Amended Drainage Report / Final Drainage Report

Midtown Courts

1417 Railroad Avenue

1.3. MODIFICATIONS TO THE PRE-LIMINARY DRAINAGE REPORT

Weir Detail at Basin:

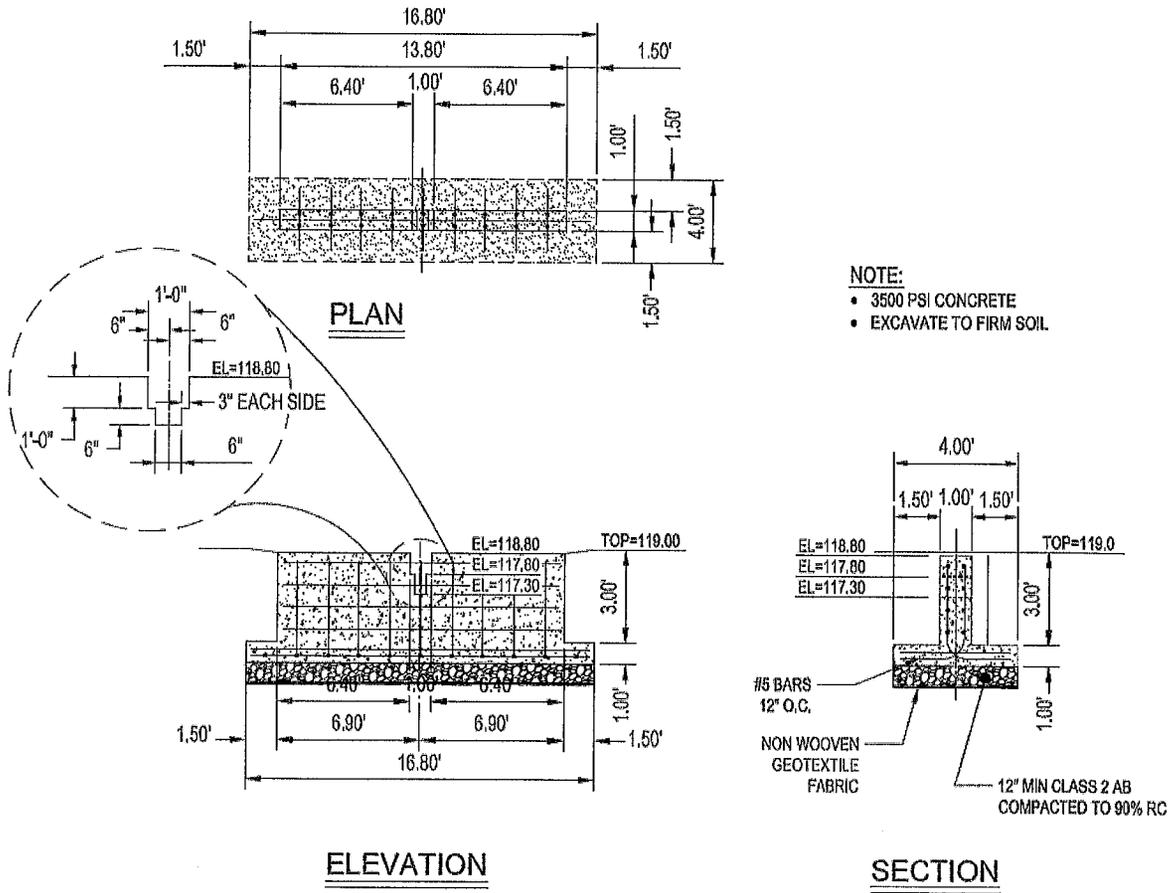
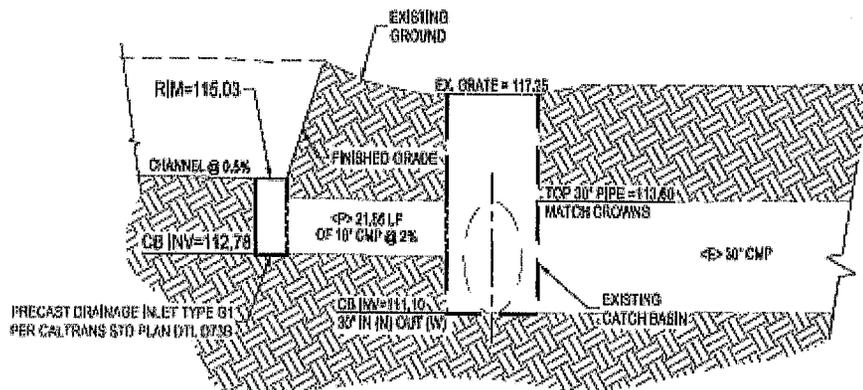
The pre-liminary drainage report remains unchanged except for one design consideration in Section 3.2 Outlet and Overflow Structure Design. This section details the overflow connection into the existing DI and as shown in the preliminary drainage report and it has been identified as a potential clogging situation presenting challenges with maintenance.

The revised approach incorporates a notched concrete weir (Exhibit B) at the outlet from the drainage basin. The sizing of all drainage facilities remains as called on in the preliminary report and the low flow and high flow overflow elevations of the weir and the outlet structure designs are shown below.
